MODIFICATION APPLICATION

Wollar Solar Farm Access Road Relocation and Subdivision

August 2020

Project Number: 20-179

Figure 2-3 Proposed modification footprint to update the General layout in the Development Consent (part 1 of 2)

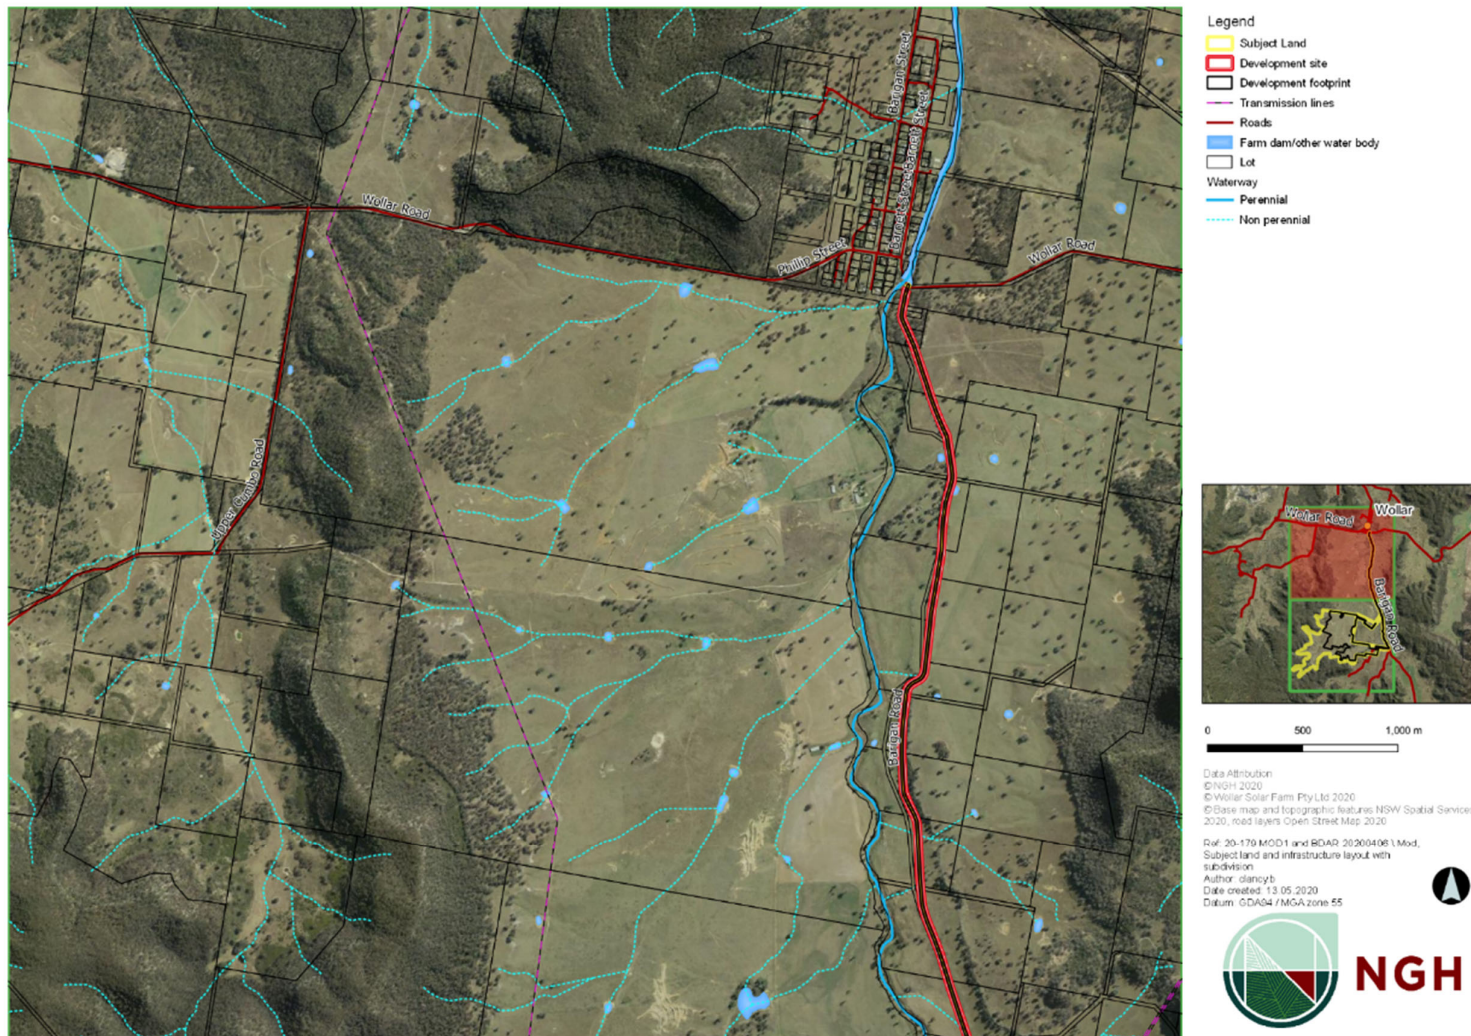
The modified site access route would require excising 1.86 hectares of project footprint (this section of track would not be required) and adding 2.16 ha of project footprint (to reflect the modified route). This

would result in a net increase of 0.3 ha to the total project footprint area. This is an increase of 0.06% to the approved project footprint.

The modified site access route would increase the area of native vegetation cleared by 0.32 ha. This is a larger area than the net change in footprint as the modified footprint includes proportionally more native vegetation than the consented footprint (that is being excised).

The proposed change in project footprint is shown in Figure 2-1, Figure 2-3 and Figure 2-4.

Figure 2-4 Proposed modification footprint to update the General layout in the Development Consent (part 2 of 2)

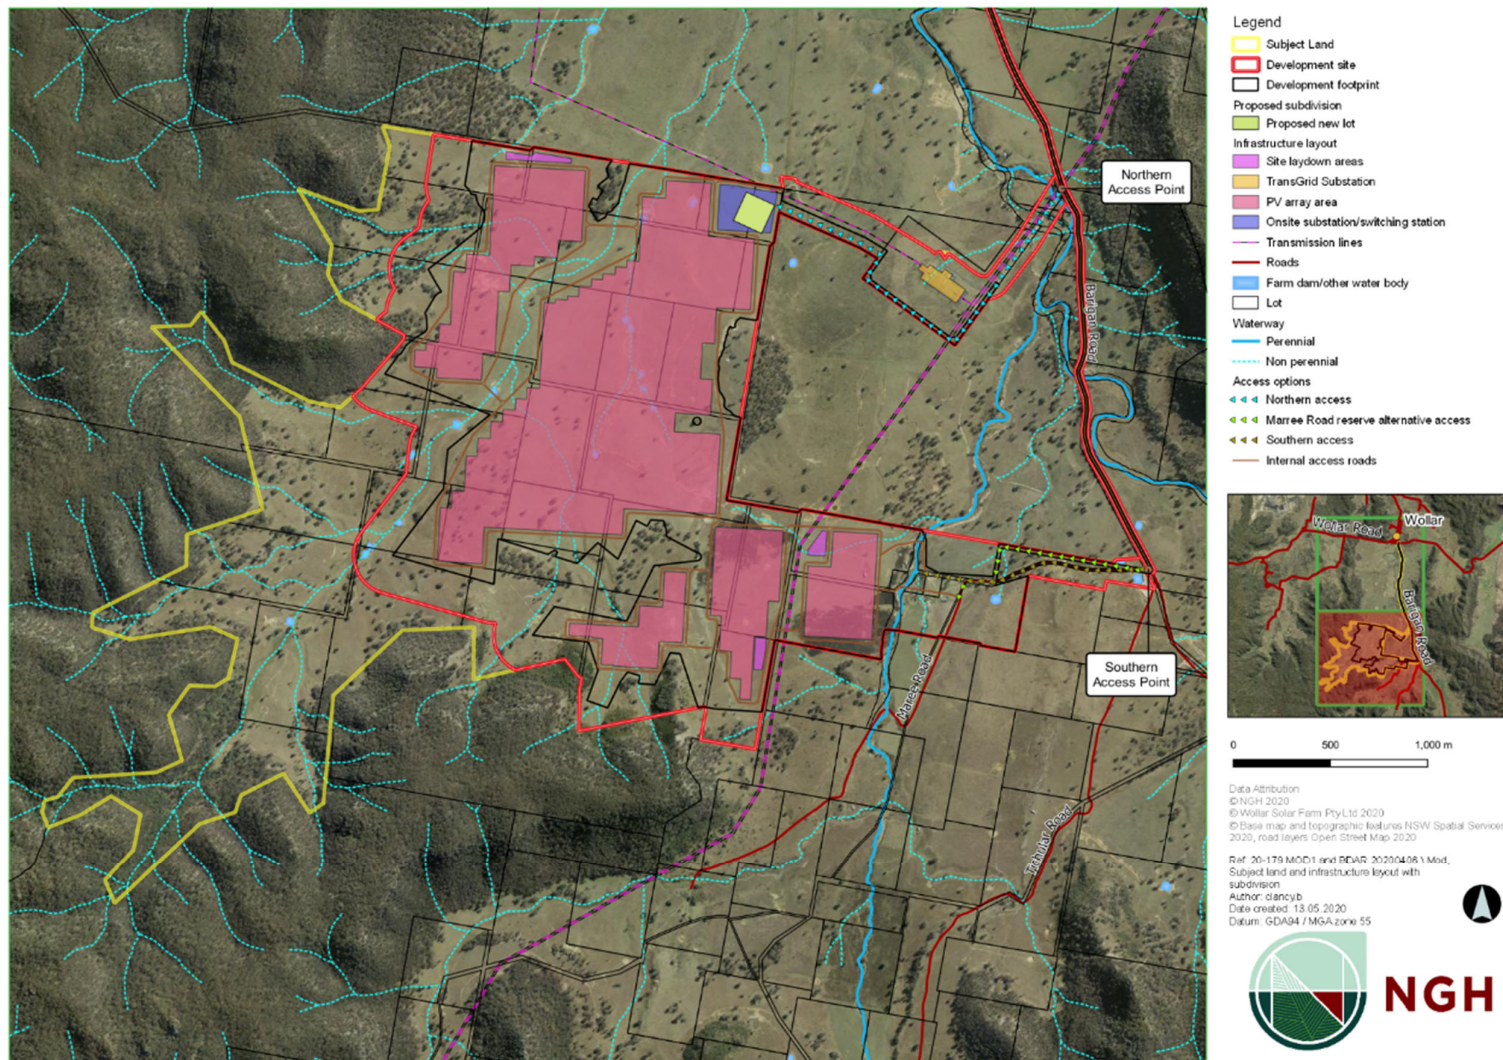
The subdivision area is shown in Figure 2-2, Figure 2-3 and Figure 2-4. The approved project footprint is shown in Appendix A. Correspondence provided to Council with regard to the need for subdivision is included as Appendix E.

1. An updated general layout, provided as Figure 2-4.
2. An updated credit requirement, to reflect the updated BDAR, as set out in Table 7-1.
3. An update to Appendix 5; items to be salvaged as part of the project's salvage works. Now provided as Appendix D.
4. An update to Appendix 2; Schedule of Lands to include Lot 7 DP1090027.
5. An update to Schedule 3, condition 1 to increase over-dimensional vehicle numbers during construction, upgrading and decommissioning to 5.
